## STA-STRAP and LINK ROD INTERFERENCE - 75 THRU 115

### MARINER AND MERCURY

75 thru 115

S/N 0D163572 thru 0D176524

**Figure 1. Incorrect Sta-Strap Position**

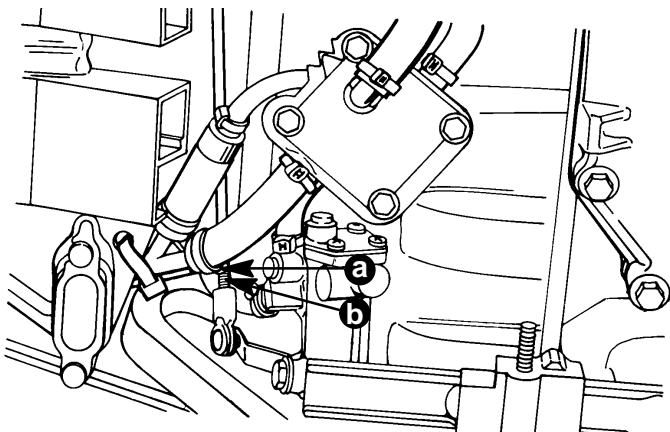
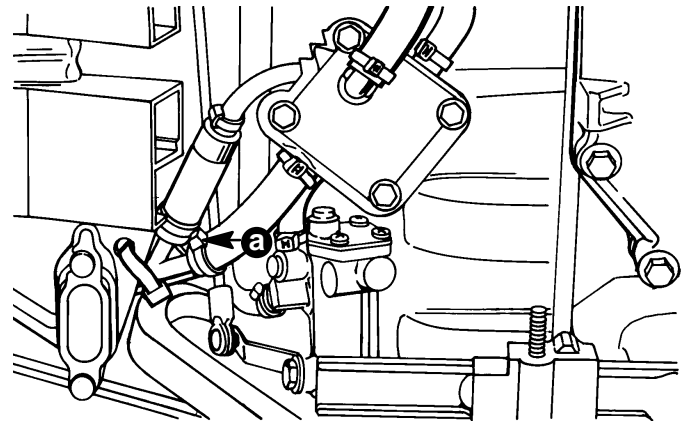
The models listed may have a fuel line sta-strap installed in a position which allows the locking tab to contact the oil pump link rod. If sufficient contact occurs, the carburetor throttle plates may not be allowed to return to the closed position and results in a higher than desired idle speed. The locking tab of the fuel line sta-strap must be positioned away from the oil pump link rod to avoid contact.

Inspect outboards listed for sta-strap and oil pump link rod interference. Correct by repositioning the existing sta-strap or by installing a new sta-strap with the locking tab away from the link rod.
